Amendments to the Drawings:

REMARKS

FIG. 1A
PRIOR ART

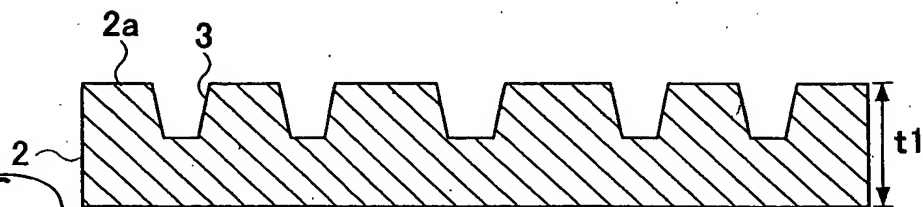
The attached sheets of drawings include revisions to FIG. 1A through FIG. 1D, each of which has been revised to add the legend –PRIOR ART— as required by the Examiner.

The drawings for the above-identified application were objected to in the Office Action mailed May 17, 2005 because the legend – Prior Art – was missing from FIGS. 1A-1D. Corrections to these figures are shown on the attached copies.
